**Response to NRC Questions on Indian Point Unit 2
P-T Limit Curves**

Request for Additional Information Indian Point Unit 2 Pressure-Temperature (P-T) Limit Curves

CONSOLIDATED EDISON COMPANY OF NEW YORK, INC.
INDIAN POINT UNIT NO. 2
DOCKET NO. 50-247
JULY, 1997

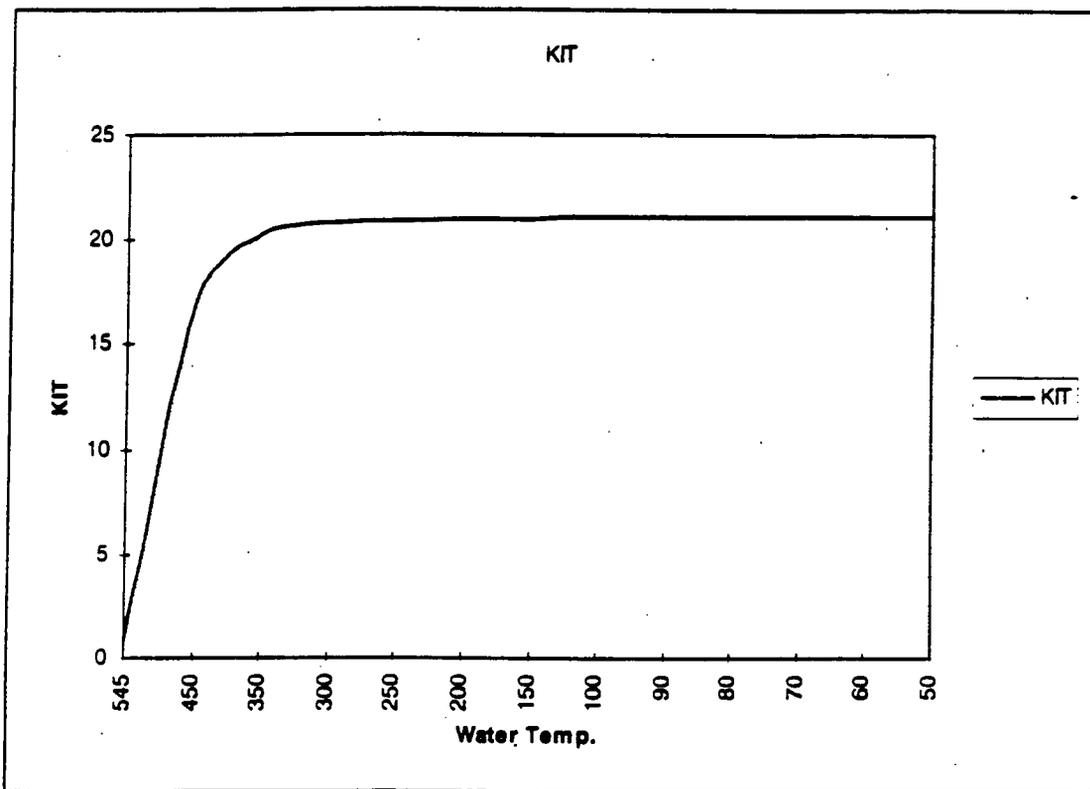
- a. *It is noted that the magnitude of the K_{IT} becomes smaller as the reactor vessel water temperature decreases. This trend is contrary to the trend from sample calculations provided by the ASME. Provide clarification.*

There are no fundamental methodology differences between the ASME sample calculations and Westinghouse calculations that generated the Indian Point Unit 2 P-T limit curves. However, the following explains the reasons why the ASME data *appears* to be increasing and the Westinghouse data to be decreasing.

The calculations provided to ASME used constant material property values. On the other hand, the Westinghouse code (OPERLIM) uses temperature-dependent material properties (as provided in the earlier Summary of Material Properties table).

As can be seen on the plots presented on the following pages, the ASME problem K_{IT} values increase *very slightly* after a water temperature of 350F. The Westinghouse K_{IT} values, as a function of water temperature, decrease slightly after 350F, then begin to level off around 150F.

These differences are due to the temperature-dependent material properties utilized in the Indian Point Unit 2 P-T limit curves.

Further, both calculations (ASME sample problem and IP2) use the same computer code (OPERLIM). And, the ASME constant property case generated by Westinghouse compared well with the three other industry approaches. Therefore, we are confident that the calculational approach of OPERLIM is correct. See the following table from the ASME sample problem.
